Re: Supplemental Filings for Pending Special Permits/Site Plan Application  
164 Grove Street, Franklin, MA

**Re: 164 Grove Street  
Site Plan Peer Review Update**

We have received the peer review letter from BETA Group, Inc. dated September 24, 2020 in regards to the revised documents for the proposed Site Plan Approval application, "**Permit Site Development Plans - 164 Grove Street, Franklin, Massachusetts**" and offer the following responses.

**TEST PIT TP-4**  
ELEV.=260.2±  
ASSUMED E.S.H.G.W. ELEV.=254.2±  
0'-39" HTM: SANDY LOAM  
39'-43" Ab HORIZON: SANDY LOAM  
43'-60" B HORIZON: LOAMY SAND  
60'-71" \*C LAYER: COARSE SAND AND GRAVEL, COBBLES

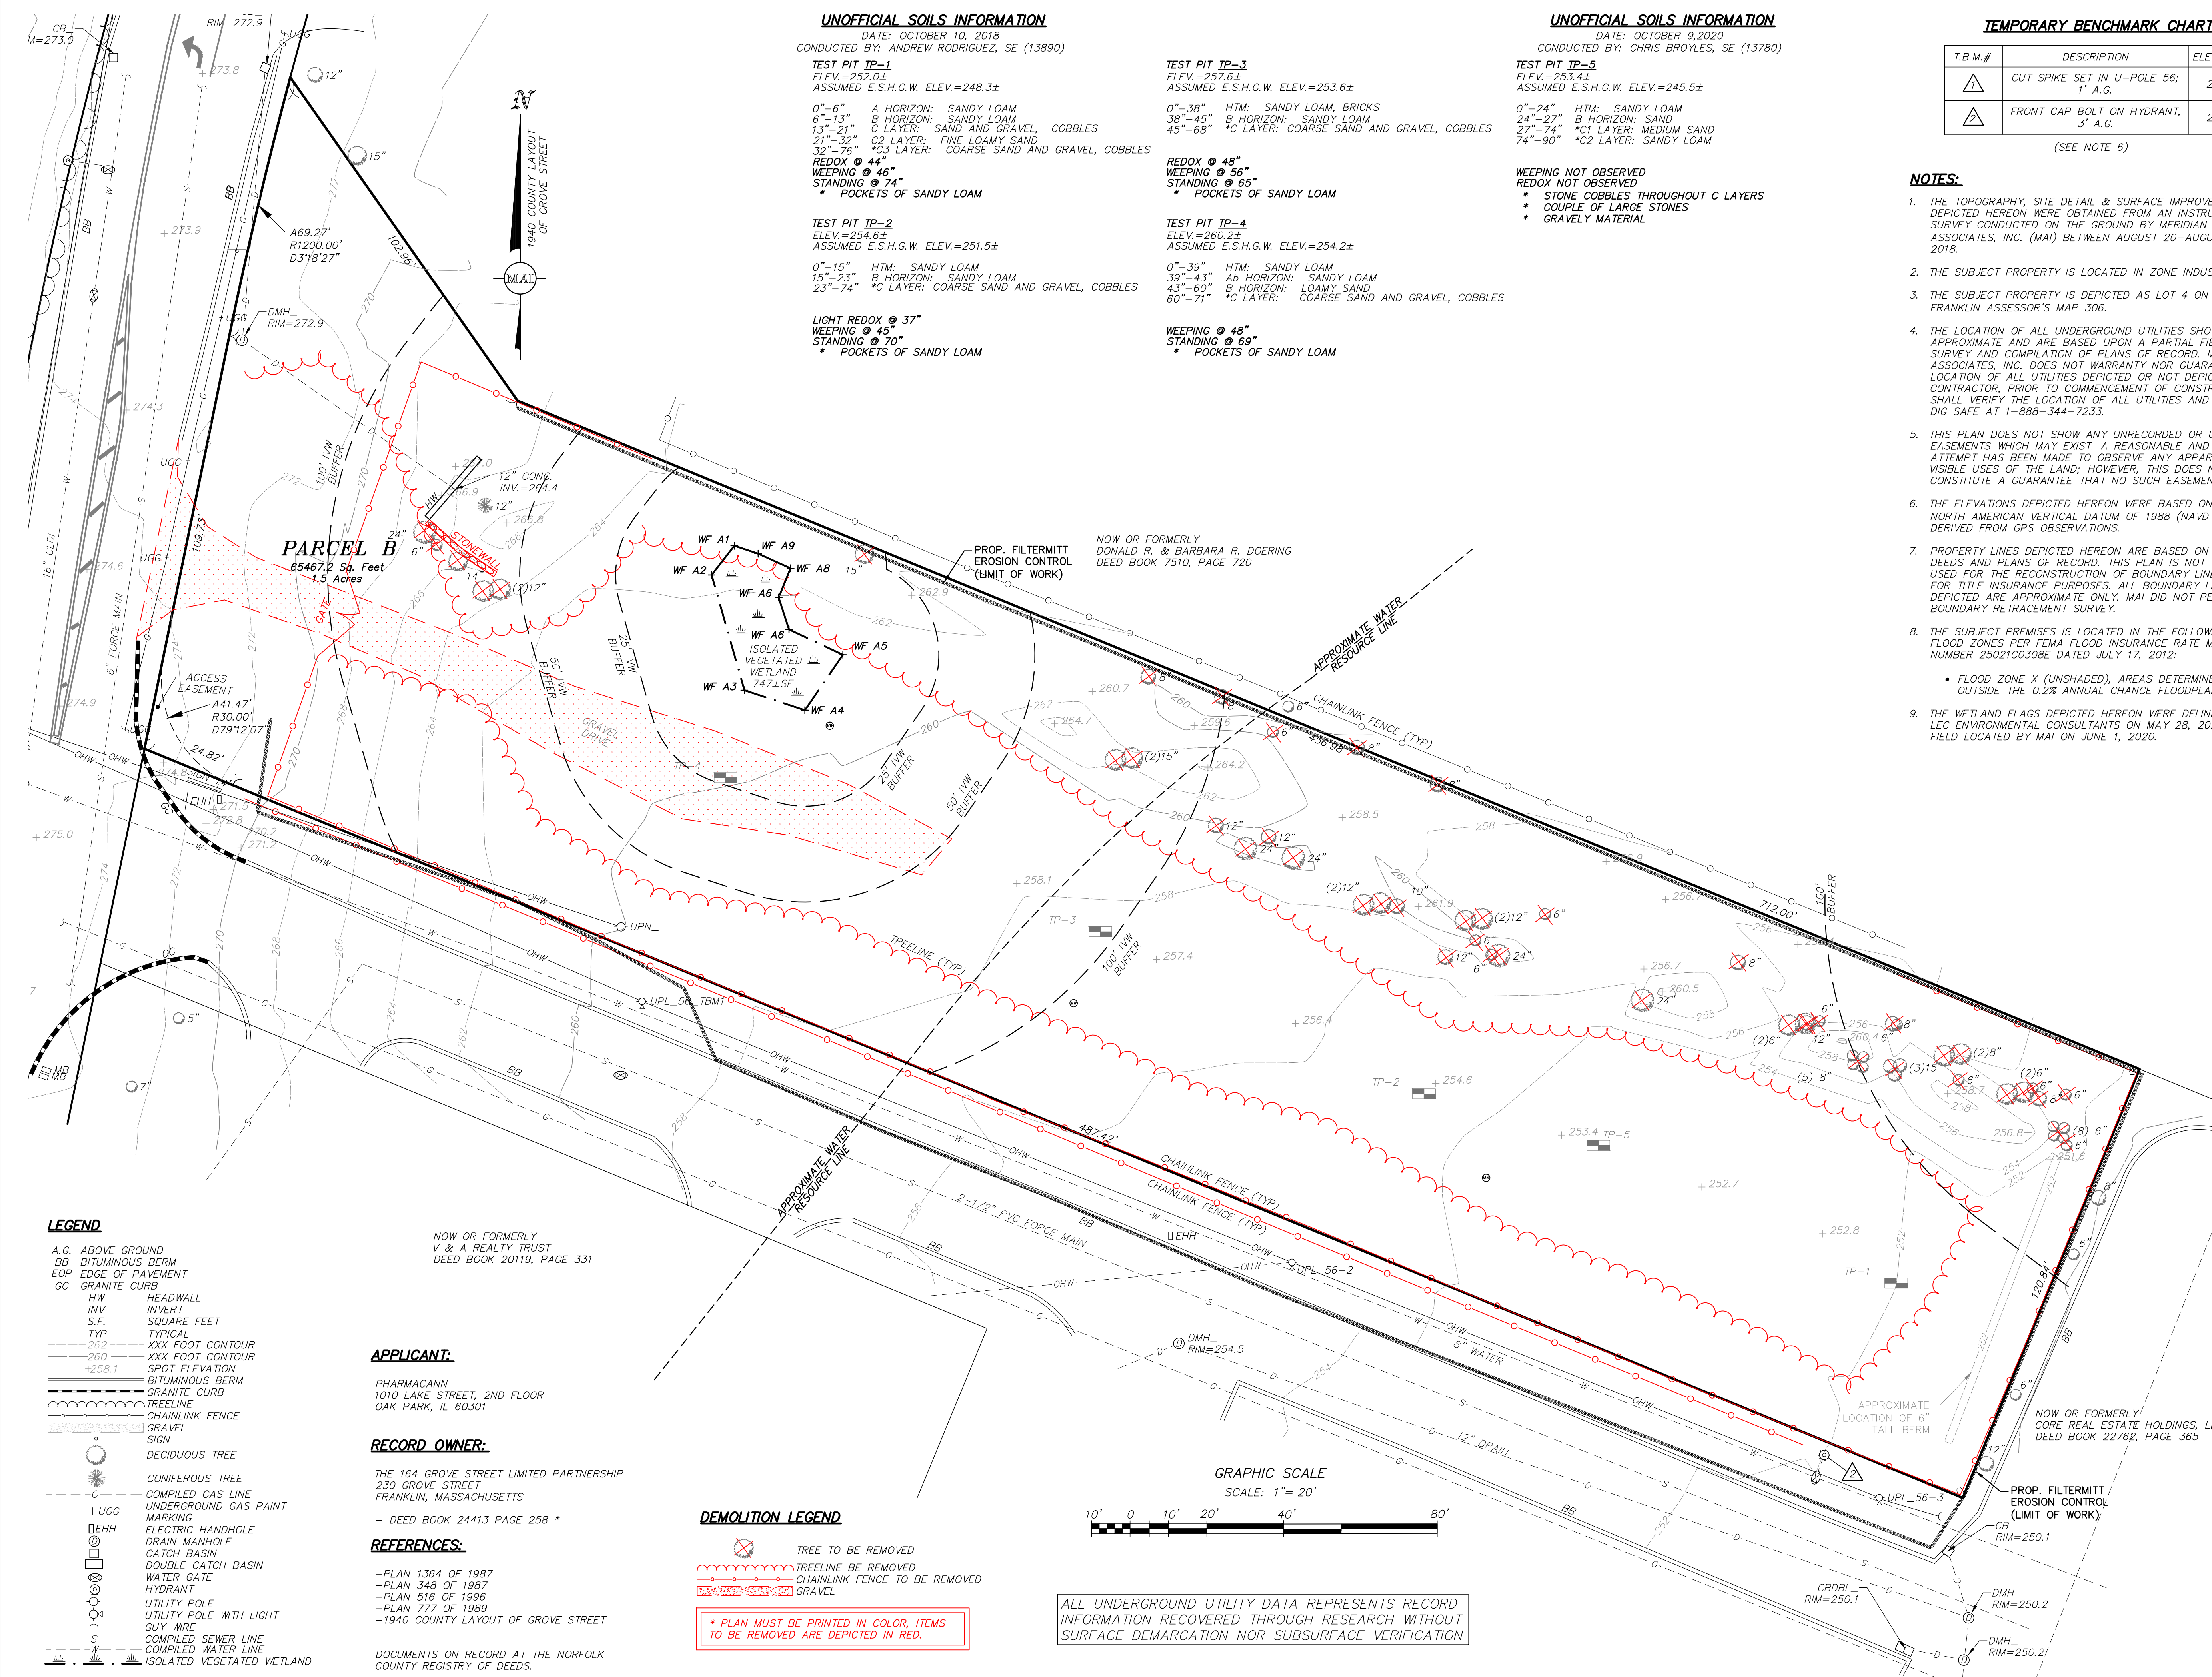
SW17. The proposed bottom of the infiltration system is at elevation 250.30 and will not provide the required 2' minimum separation to groundwater based upon the soils analysis for Test Pit 2 (ESHW @ 251.5). *MAI: The bottom elevation of the infiltration basin is two (2) feet above the groundwater encountered in Test Pit #1 (248.3), which is located adjacent to the infiltration system. BETA2: Information provided which indicates the eastern side of the proposed infiltration system*

has the required 2' separation to groundwater; however, the groundwater profile created by the additional test pit information cannot be discounted for the remainder of the system. Either revise the system to provide the required 2' separation throughout the system based on the groundwater profile or provide an additional test pit at the western side of the proposed system to demonstrate a consistent groundwater elevation. *MAI2: A confirmatory test pit can be dug in the western portion of the infiltration system prior to construction to confirm the groundwater elevations. If that test pit depicts a higher than anticipated groundwater elevation, modifications to the drainage system will be made at such time.* **BETA3: In consideration that the entire stormwater system design is contingent on this subsurface infiltration system and that it is anticipated that additional test pit information will indicate a groundwater table within 2 feet of the infiltration system, BETA recommends for the issue to be resolved at this time.**

**MAI Response:** On October 9, 2020 an additional test pit was performed by a Registered Soil Evaluator and a Professional Engineer, at the western edge of the infiltration system. The test pit log and location are shown on the Record Conditions and Demolition Plan. The results show that there will be greater than a two (2) foot separation to groundwater, therefore modifications to the stormwater design are not required.

C2.0

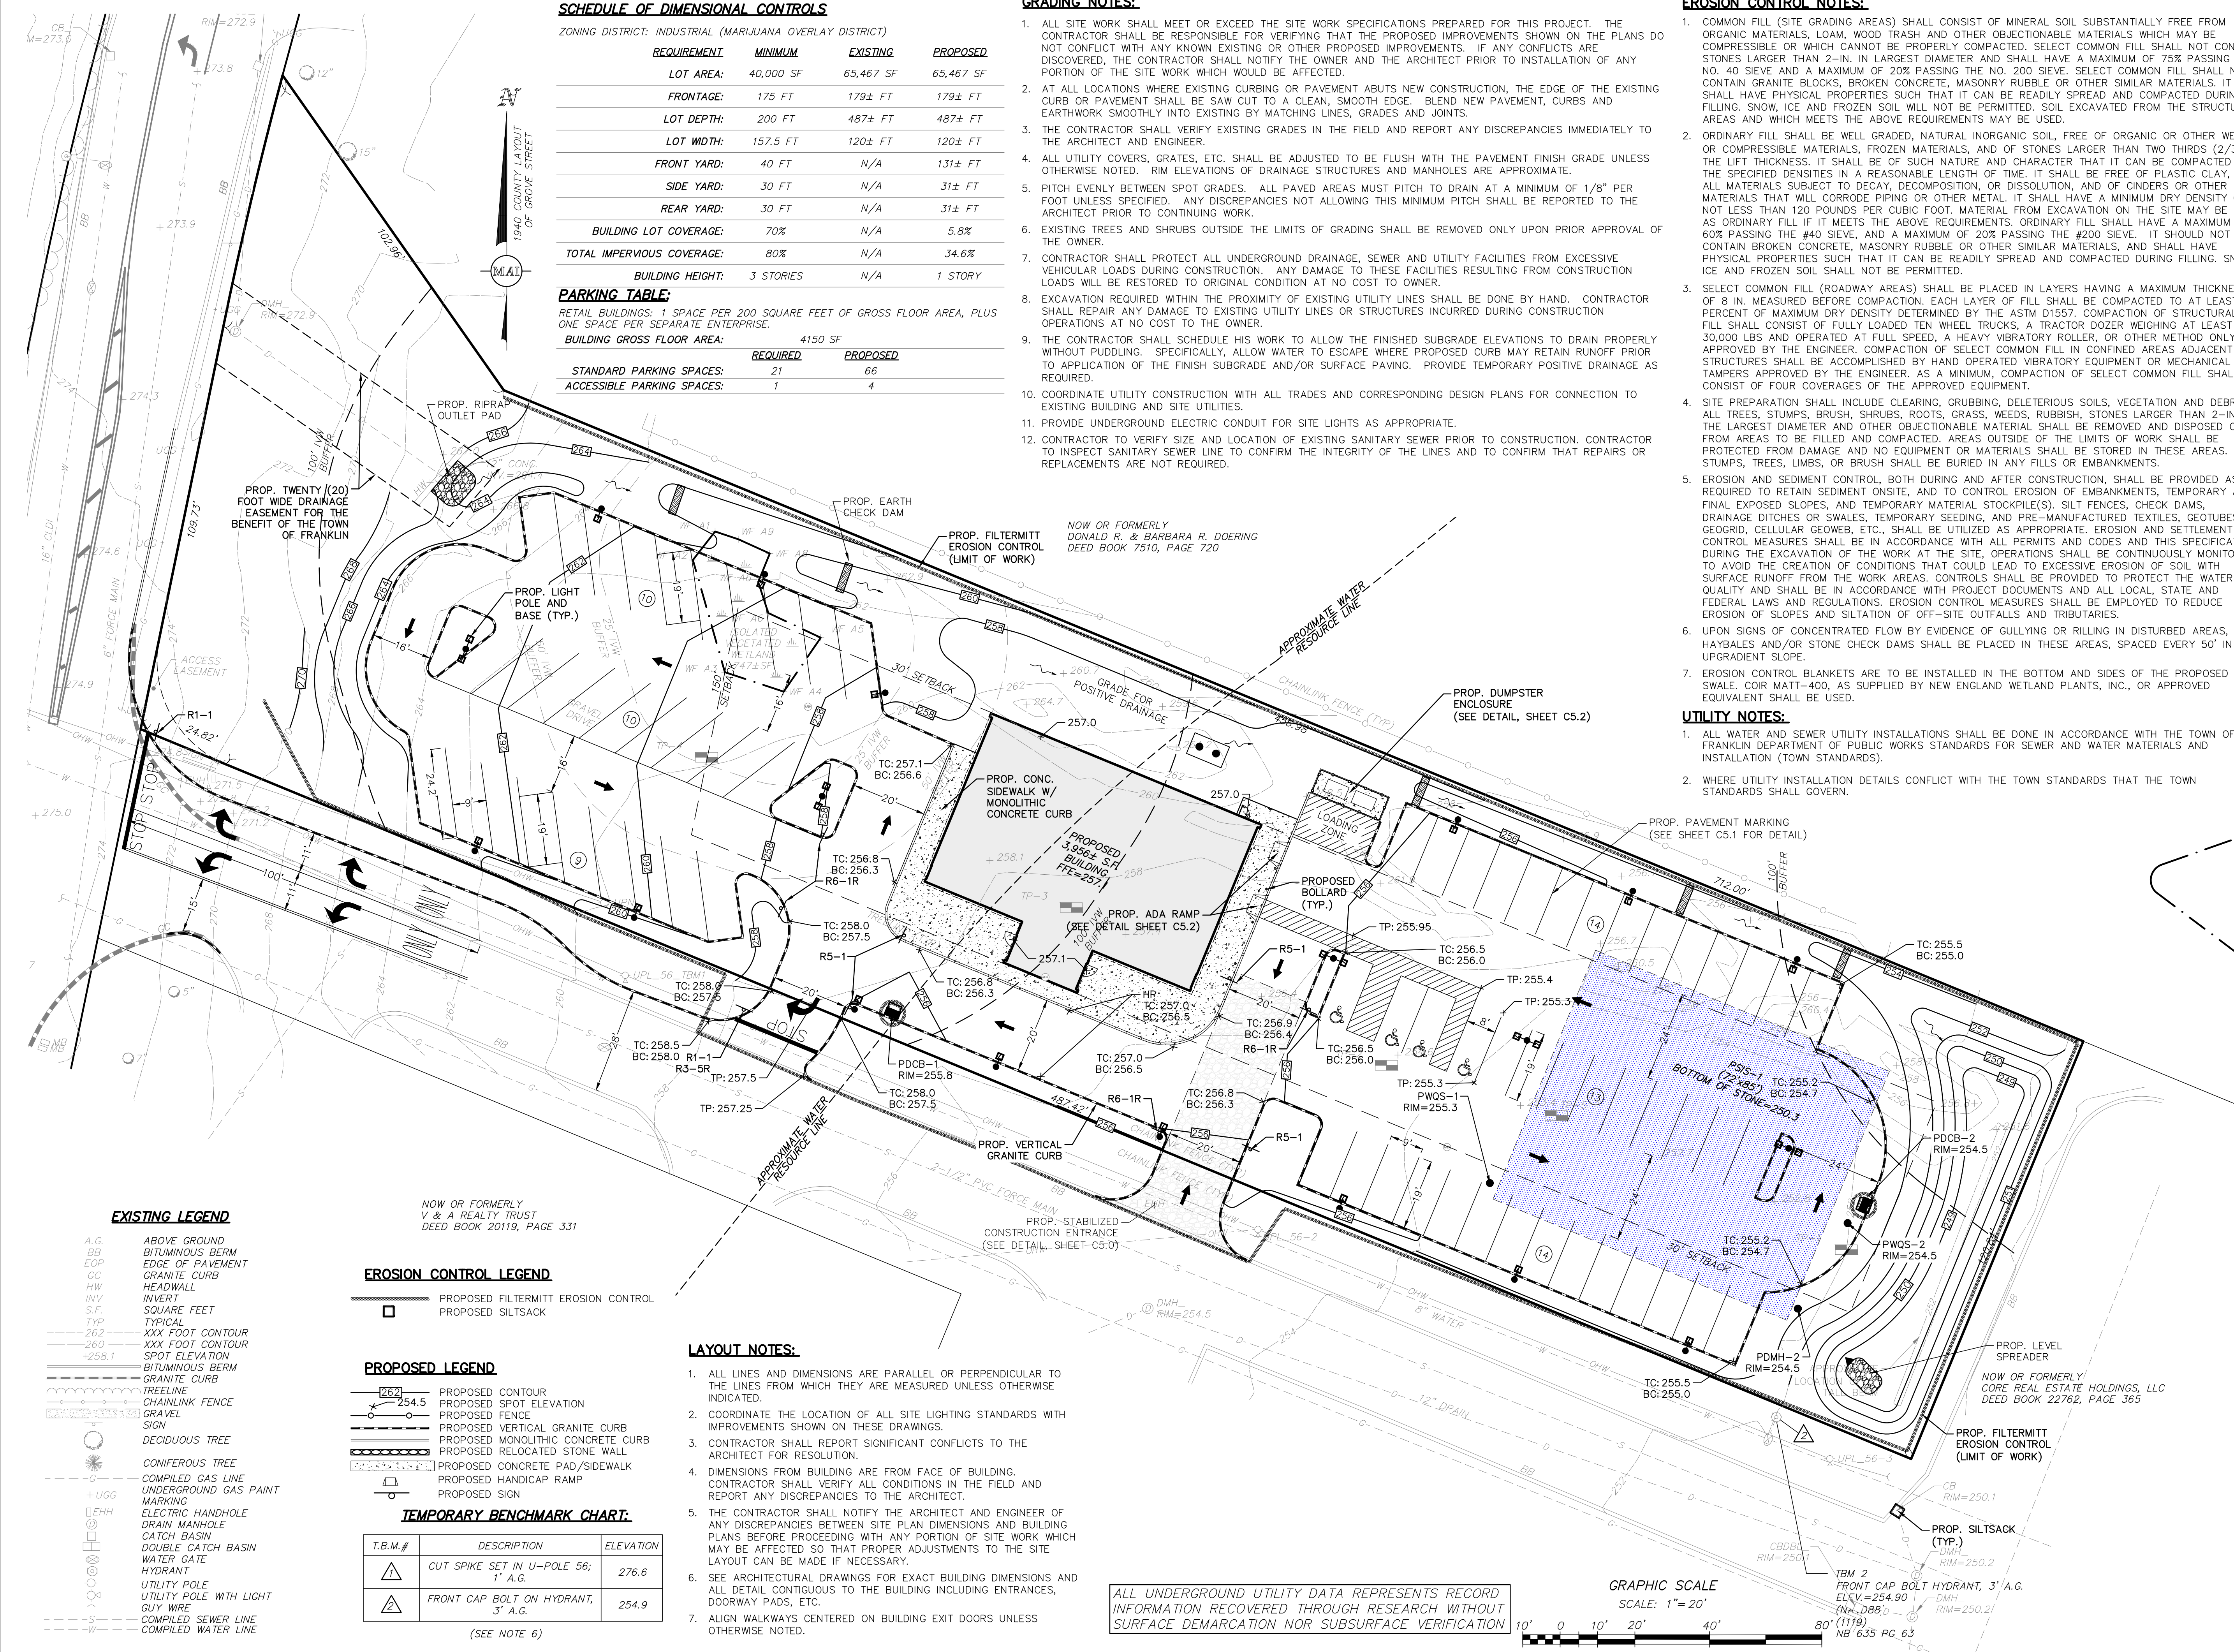
- P1. The angled parking layout conforms to industry standards; however, the usable stall length is only 18 feet. Revise the usable stall length to be 19 feet §185-21.C.(9)(a). *MAI: The length of the angled parking spaces has been revised accordingly, refer to Sheet C 2.0.* **BETA2: Stall length revised – issue resolved.**

- S11. Clarify limits of vertical granite curb as it relates to the concrete walkway. The Concrete Walkway Detail depicts monolithic concrete curb. *MAI: The limits of the types of curbing have been clarified, refer to Sheet C 2.0. BETA2: Clarification provided – issue resolved.*

SW4. In coordination with the Town, provide an easement for the existing outfall at the northwest end of the site. *MAI: An easement for the town at the headwall has been depicted graphically on the plan set, refer to Sheet C 2.0. BETA2: Easement provided. BETA defers any additional comment to the DPW.*

SW6. Consider providing periodic check dams in the northerly swale to minimize flow velocities and promote infiltration. *MAI: Check dams have been added to the plan set, refer to Sheet C 2.0. BETA2: Check dams provided – issue resolved.*

SW8. Although the existing outfall at the northwest corner of the site is not the responsibility of the project proponent, it is recommended to provide a rip rap pad at the outlet. *MAI: A rip rap pad has been added to the existing outfall pipe, refer to Sheet C 2.0. BETA2: Rip rap pad provided – issue resolved.*
